Riverside Energy Park

Statement of Common Ground: Environment Agency

8.01.03

May 2019 | Revision 0 (Deadline 2)

Date	13.05.19
A1 Scale	1:250
Drawn by	AG
Checked by	PC
Drawing Number	VAA-WA-50080101_1.0

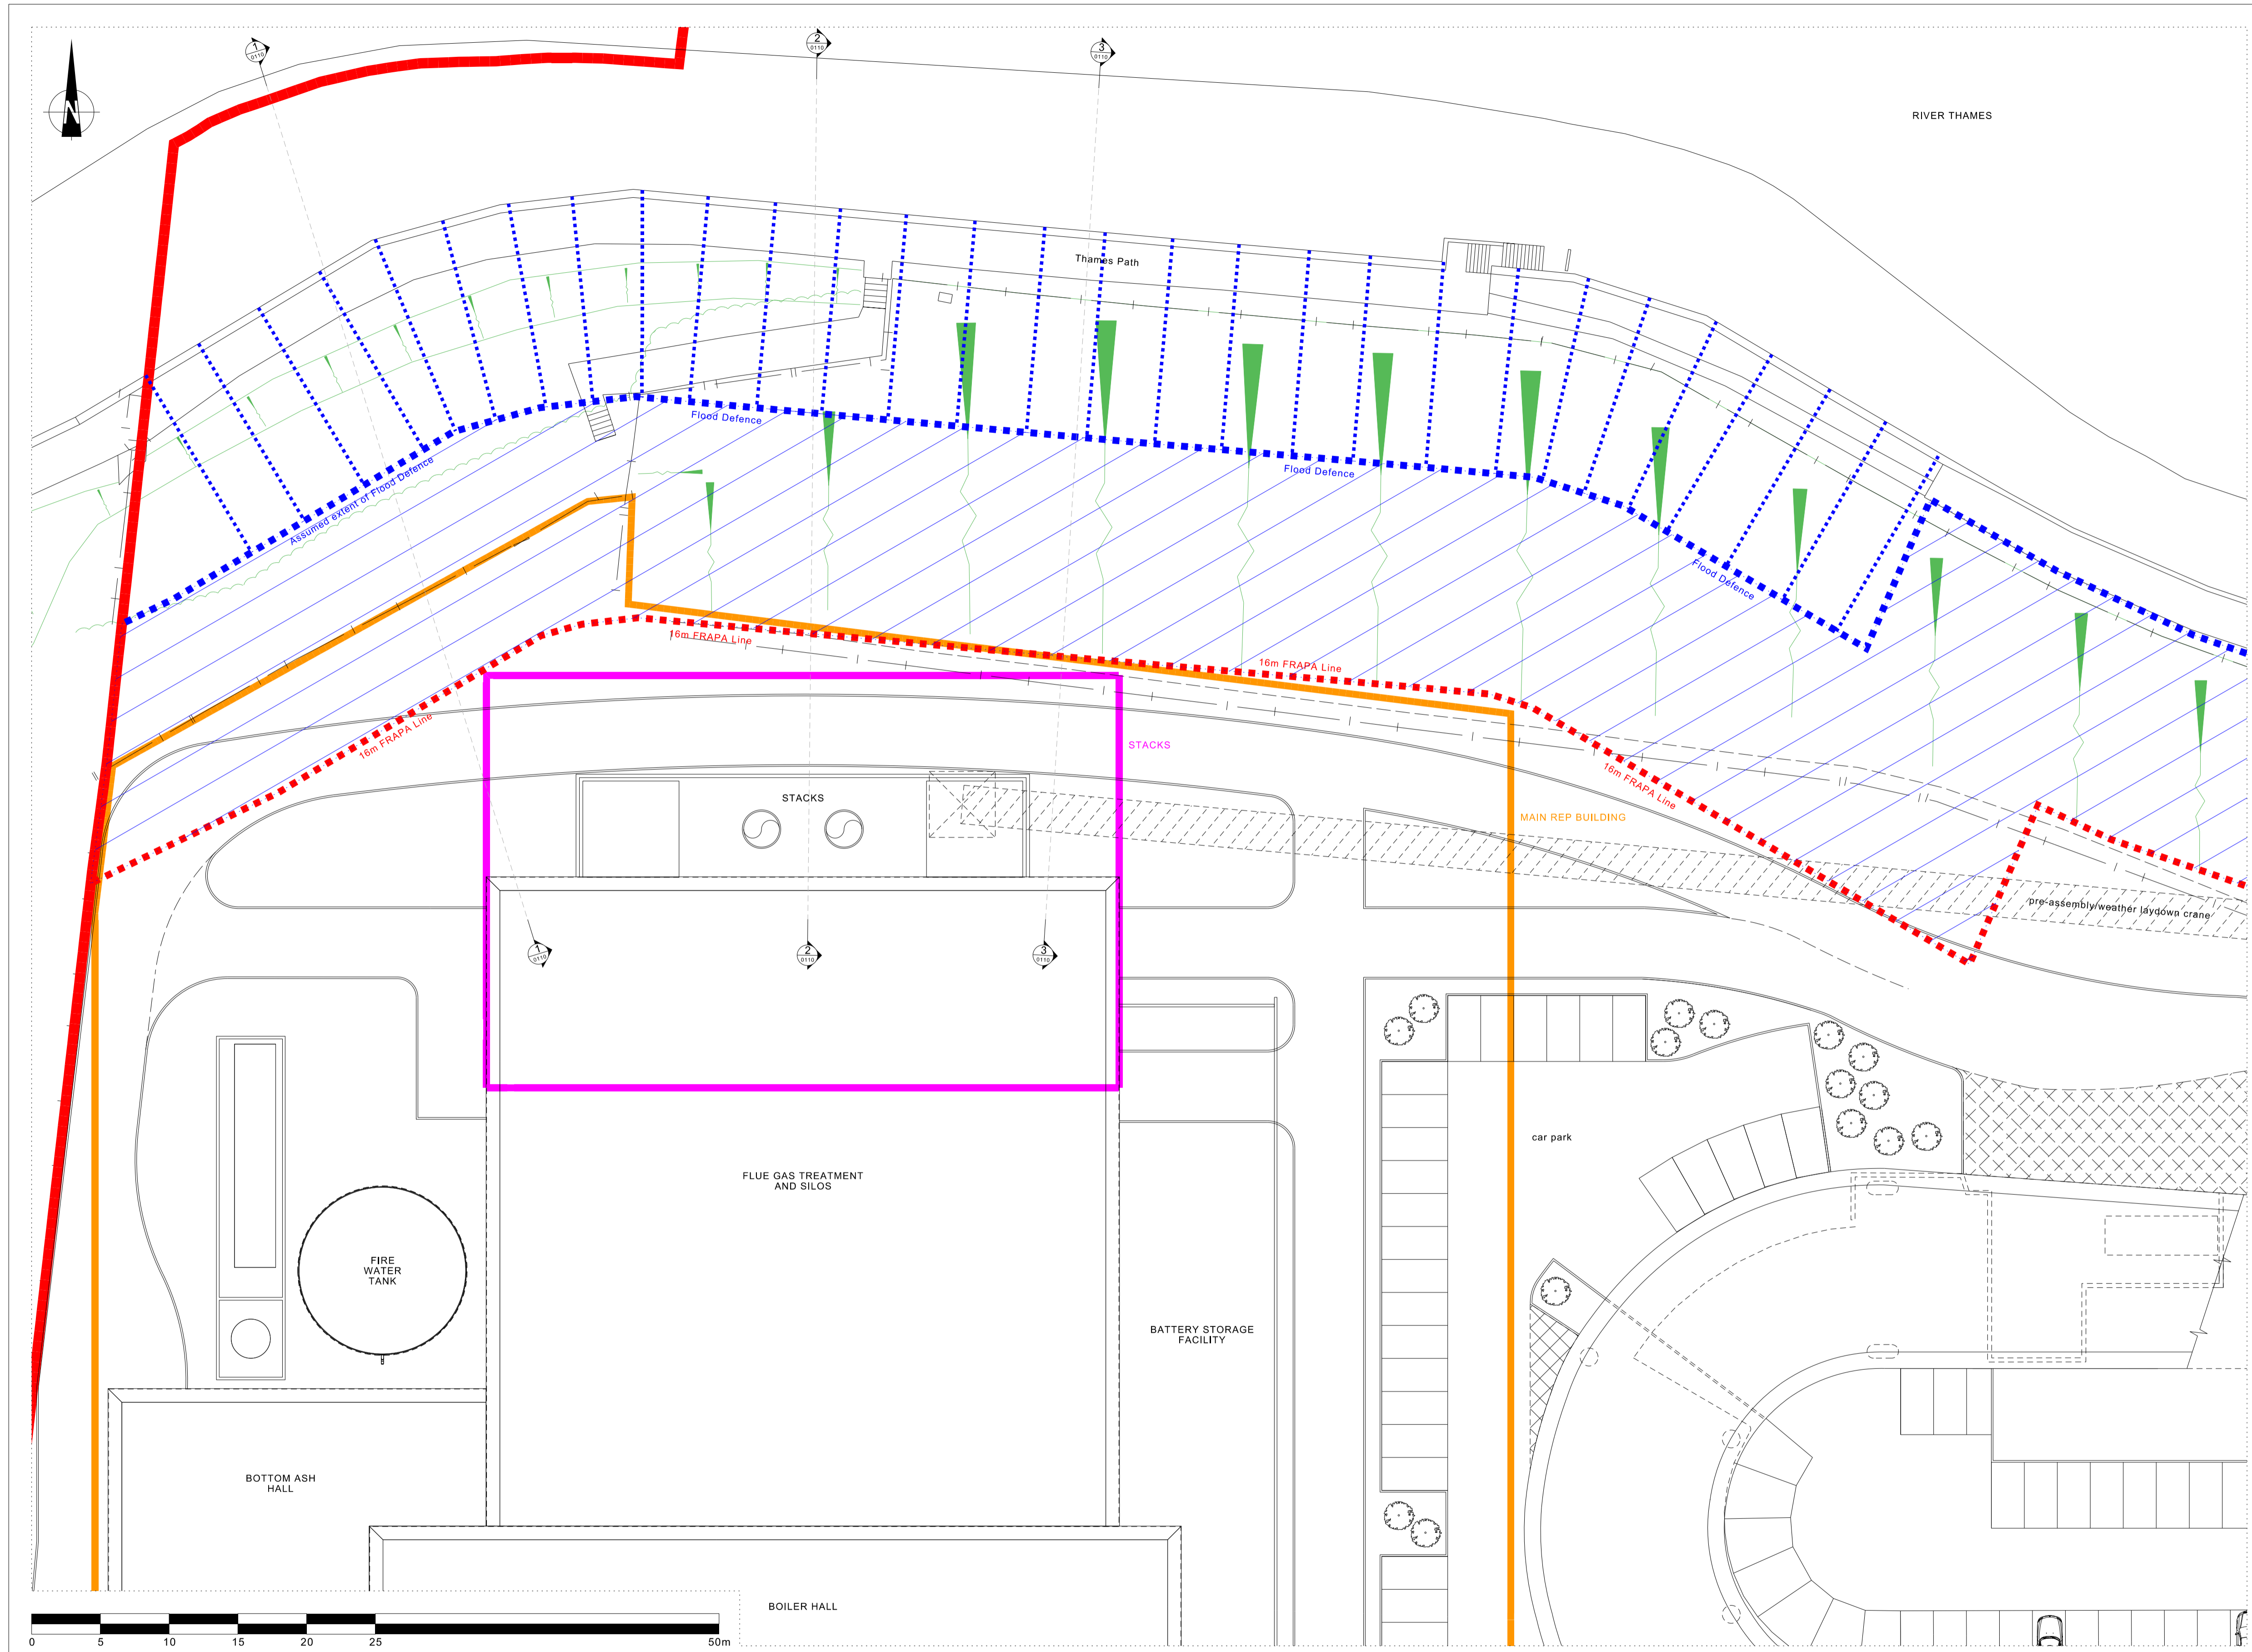
2.3.4 During operation of REP, activities within the FRAPA are anticipated to include a service road (as indicated in diagram VAA-WA-50080101_1.0). The Parties agree that no buildings (as defined within the **dDCO (3.1; Rev 1)** as “..includes any structure or erection or any part of a building, structure or erection”) will be placed within the Flood Risk Activity Area. This wording will be reflected in the protective provisions at **Part 4 of Schedule 10 of the dDCO (3.1; Rev 1)** once agreed.

The EA has requested that the parameters of the Main REP Building are modified to ensure that they do not overlap the FRAPA. However, the Applicant considers the commitment to no buildings (as defined within the **dDCO (3.1; Rev 1)** as "...includes any structure or erection or any part of a building, structure or erection") within the Flood Risk Activity Area covers off this issue, as reflected in this SoCG and will be included in the protective provisions once agreed.

Date	13.05.19
A1 Scale	1:100
Drawn by	AG
Checked by	PC
Drawing Number	VAA-WA-50080110_1.0

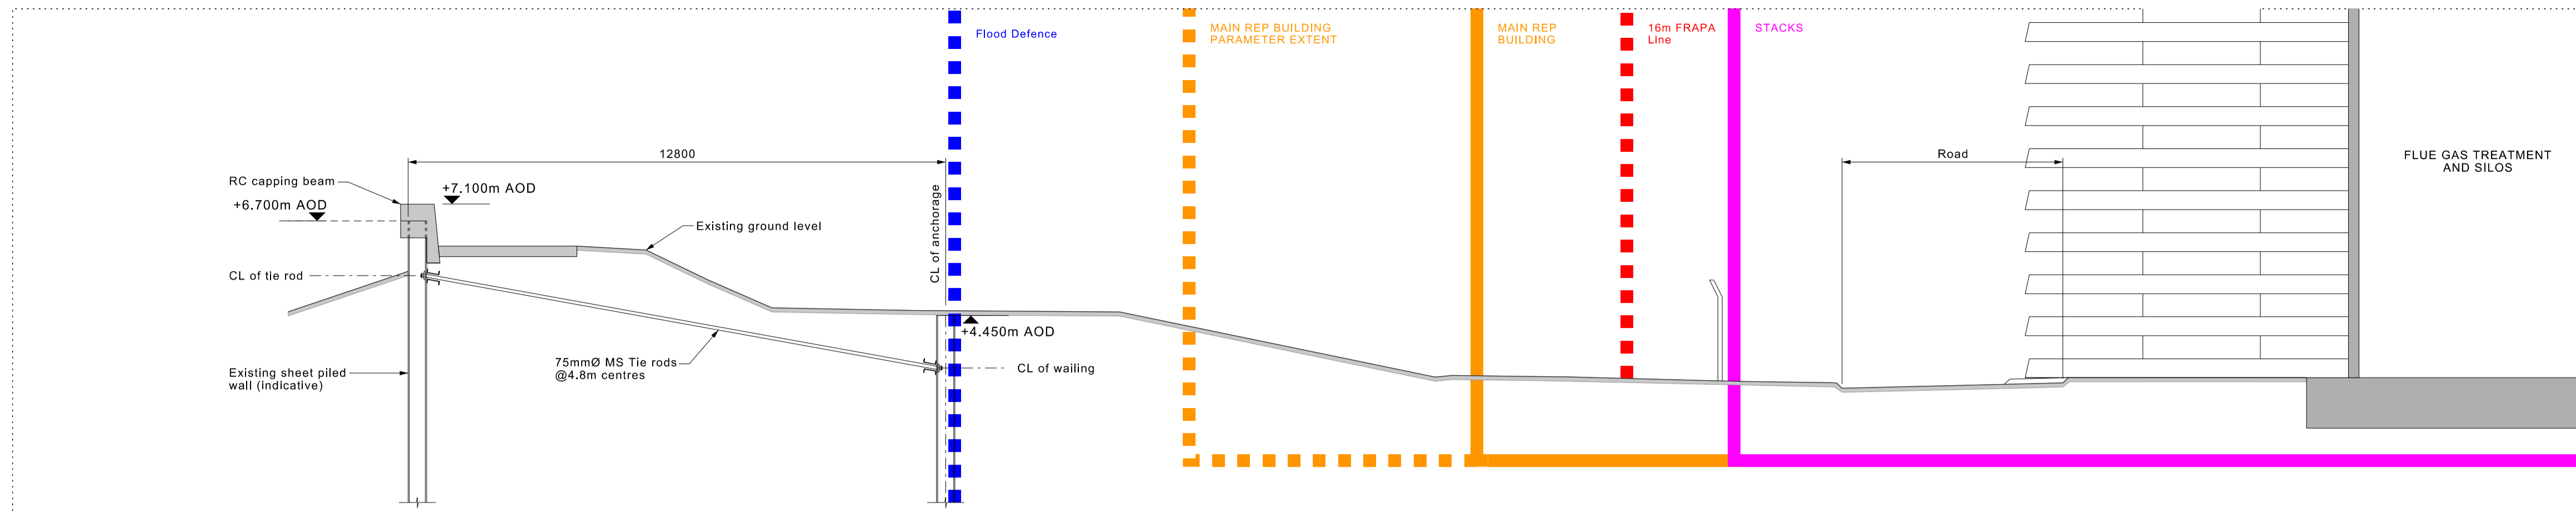
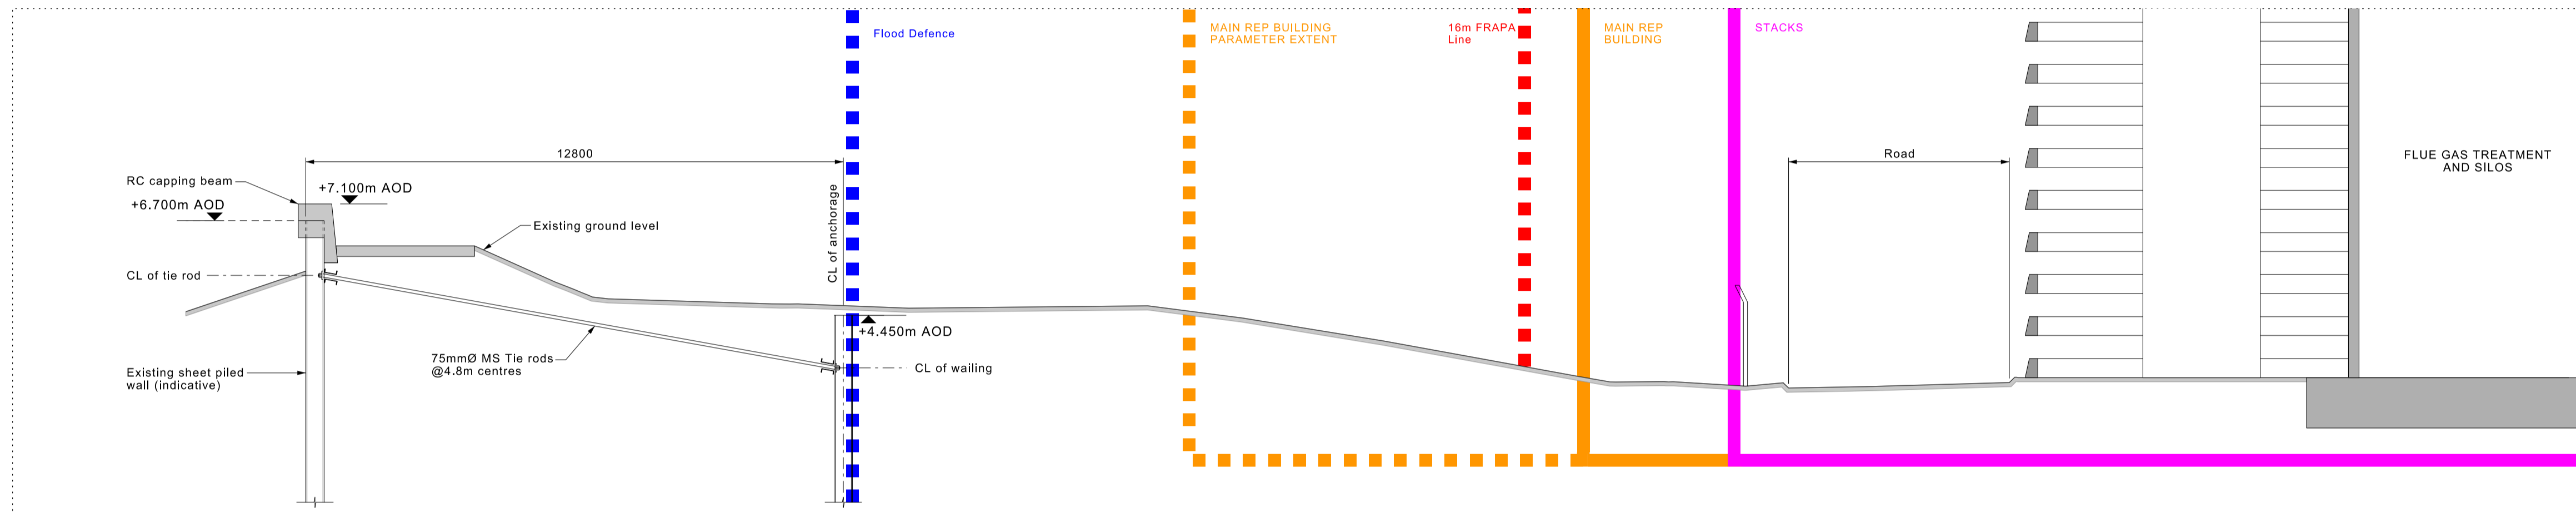
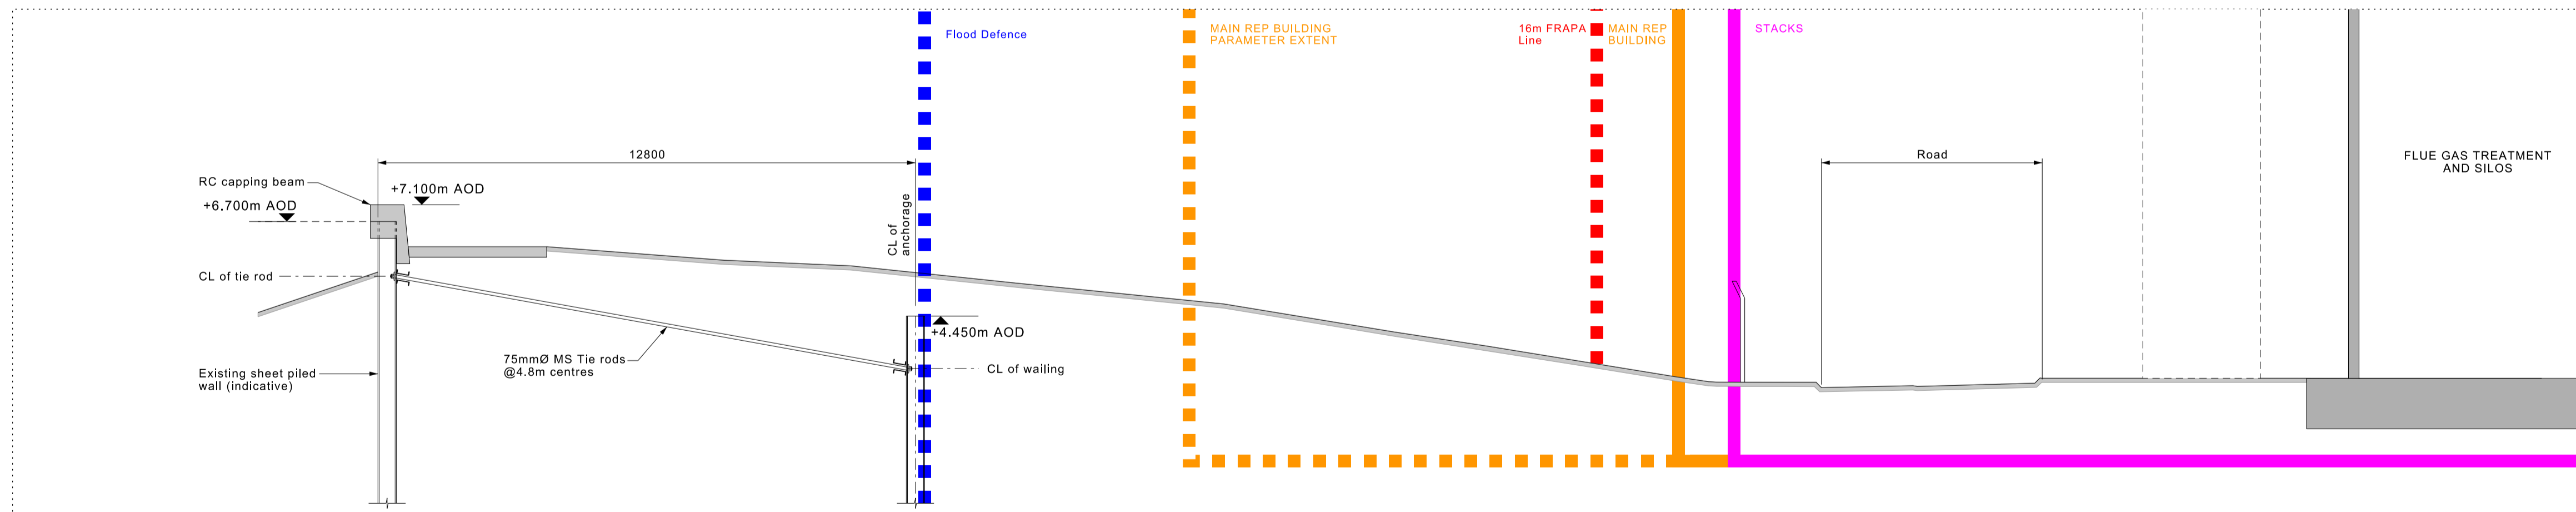
2.3.1 The Flood Risk Activity Permit Area (FRAPA) for REP is shown in diagram VAA-WA-50080100_1.0, VAA-WA-50080110_1.0 and VAA-WA-50080101_1.0 appended to this SOCG.
